Pinehaven Structural Works - Technical Review - Flooding

Peer Review

Prepared for Greater Wellington Regional Council
Prepared by Beca Limited

21 November 2019

Figure 4-8 100-year ARI long-section

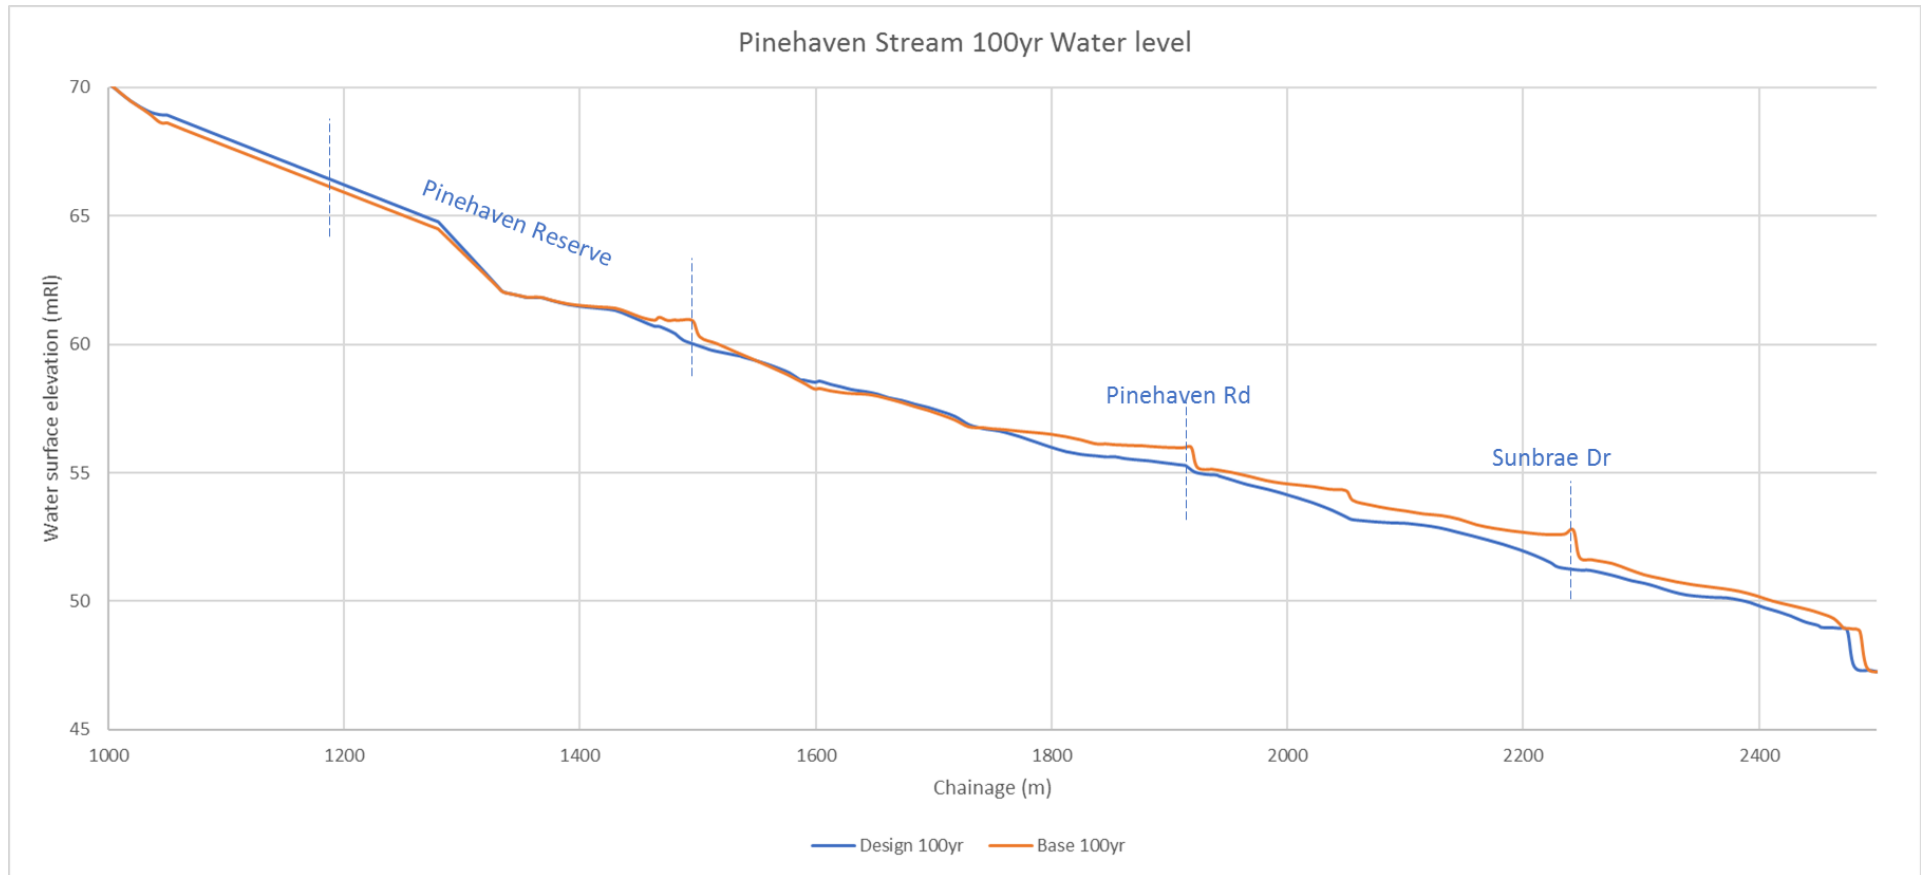
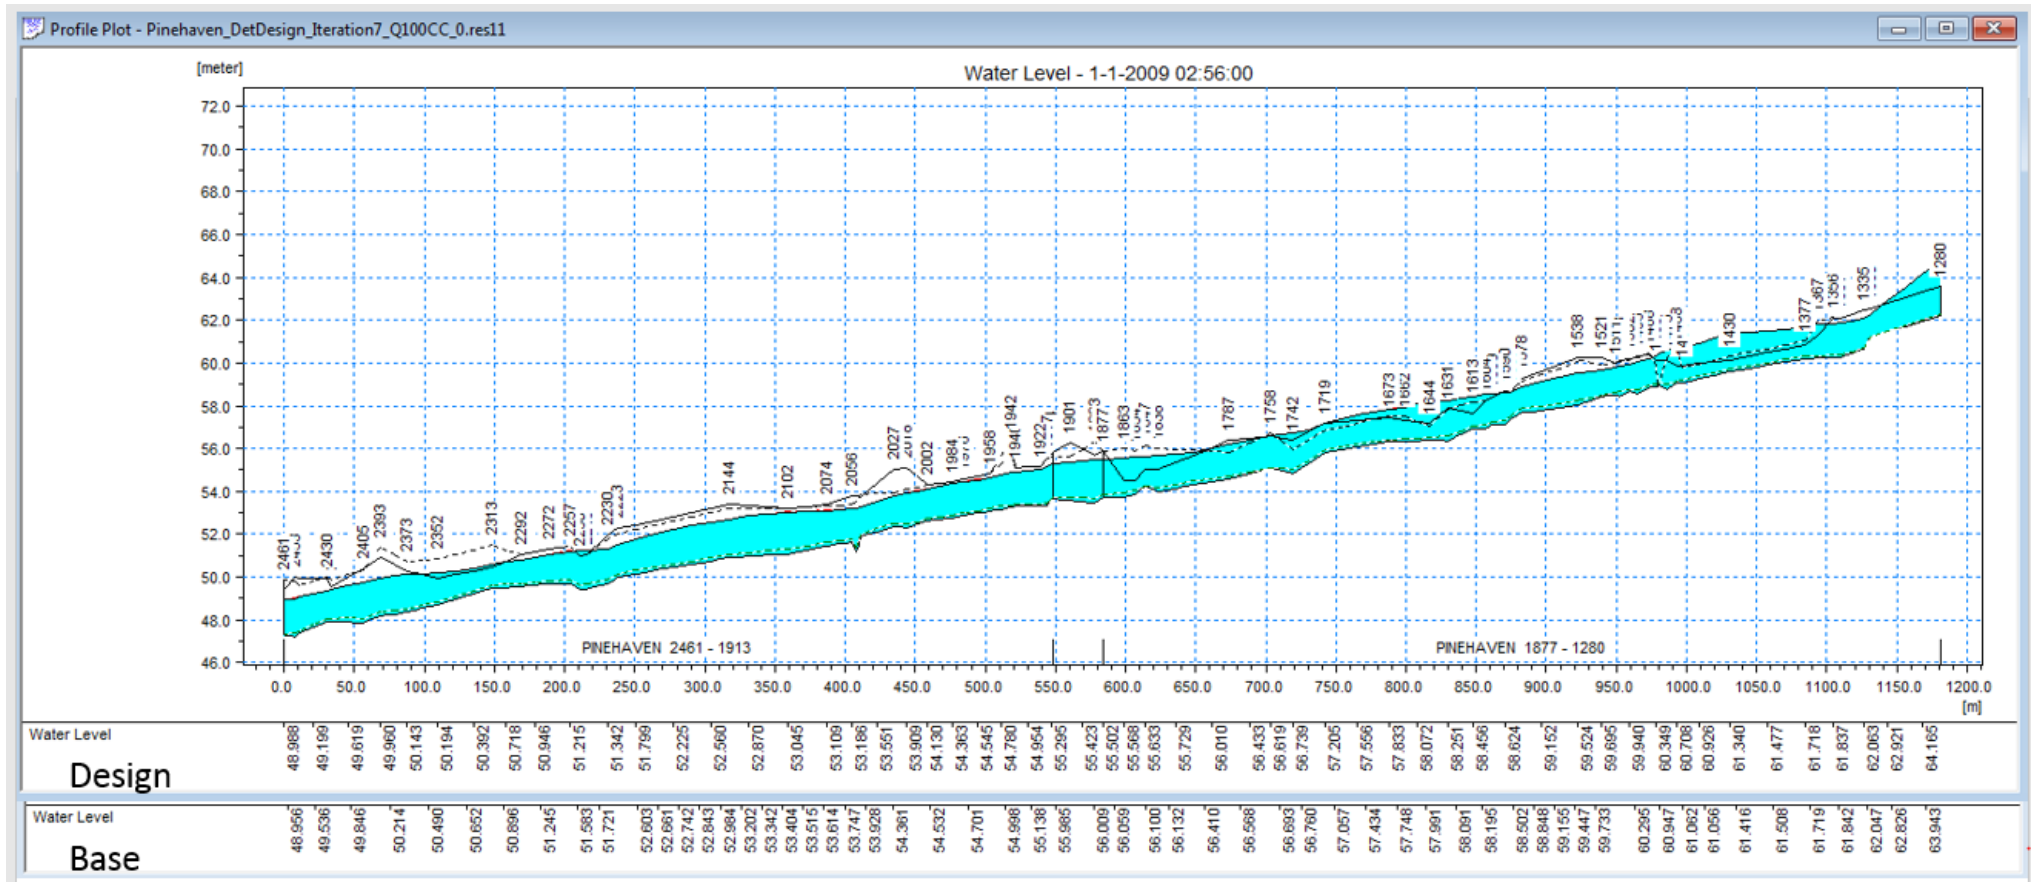
MIKE11 Water levels	The HGL plot in Figure 4-8 and Figure 4-9 shows that the 100-year ARI event water levels are reduced in most stretches of the stream due to the stream widening and larger culverts. Two sections have increased in water level. <ul style="list-style-type: none"> The piped section in and upstream of Pinehaven Reserve. This is unexpected, as we assumed that there were no changes in this reach and do not expect it to be affected by the stream works. <u>Is the modeller able to explain this?</u> A short section at Ch.1600. Near 2A Freemans Way (as stated in the executive summary of the Flood Hazard Assessment report) 	The piped section in Pinehaven Reserve was not checked because it is outside the area of main channel works. Differences in water level do not affect containment within the channel (as this is a piped section) or habitable floor flooding (as the area is a reserve). Near 2A Freemans Way there are no channel works proposed. The differences are thought to be due to a combination of channel works upstream directing more flow into this reach instead of entering the Birch Grove area and a slight change in timing of the flood peak.	Uncertainty over the cause of the raised water levels through the reserve is not expected to adversely affect the relative effects of the stream works, and so does not materially affect the 'fit for use' categorisation. However, the Reviewer notes that the issue is not resolved and so the issue will remain open OPEN	2	Yes

Figure 4-10 100-year ARI MIKE21 (2D) flood extents.

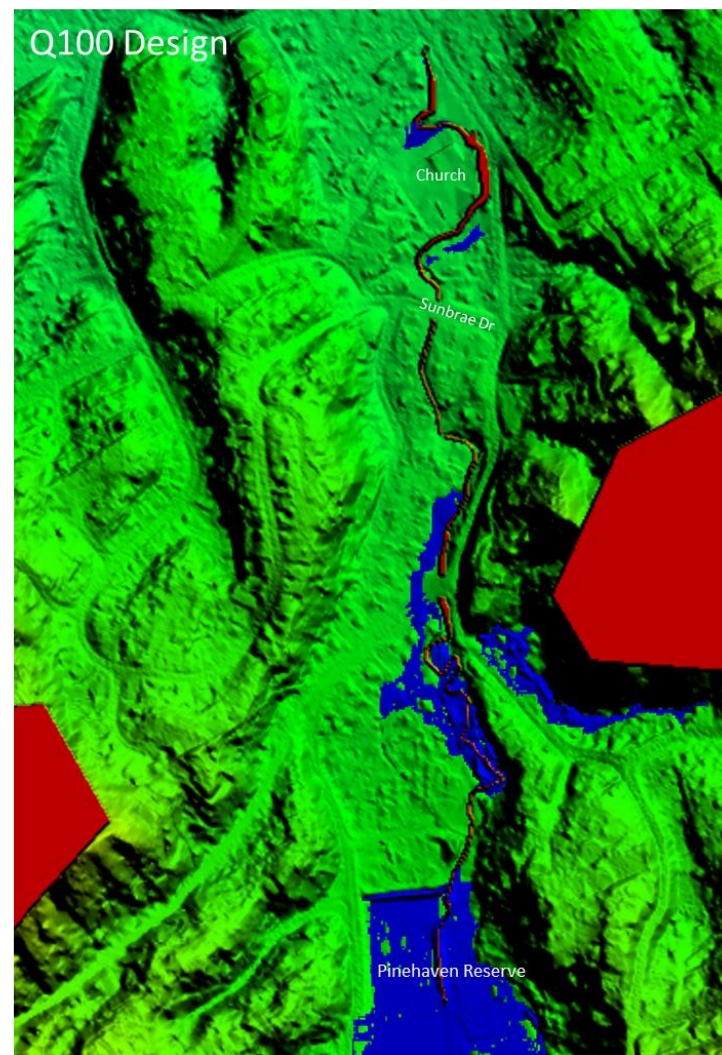
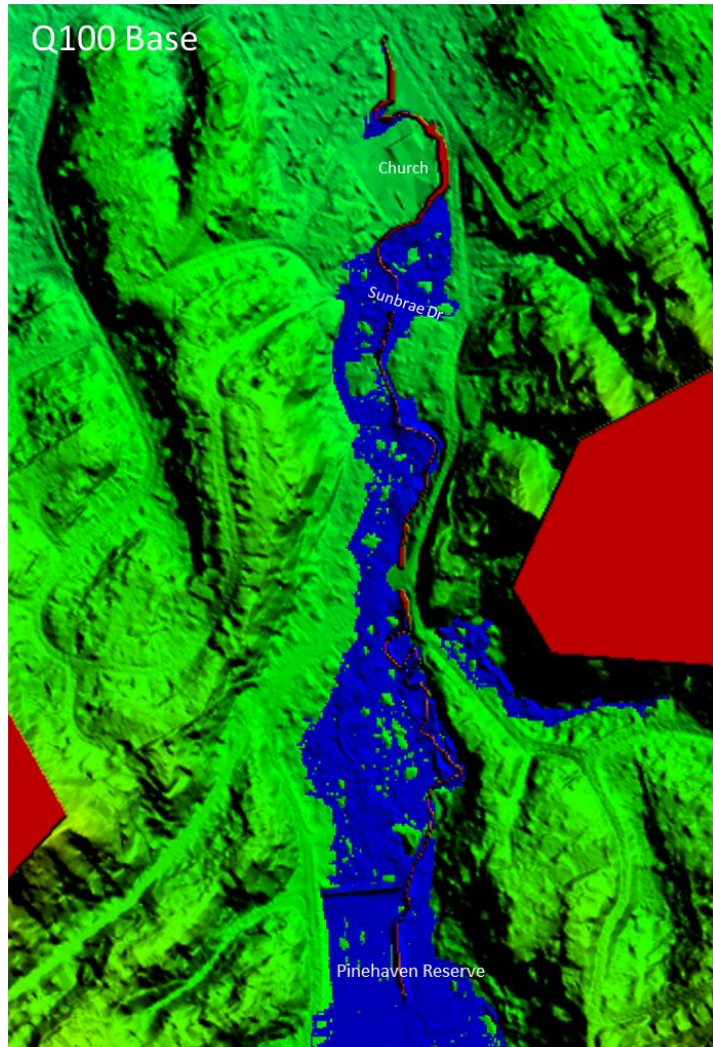
MIKE21	Downstream of Pinehaven reserve there is a significant reduction in flood levels. These are replicated in both the M11 water levels and the M21 results (Figure 4-10).	Noted; agreement with comment.	CLOSED	0	Yes
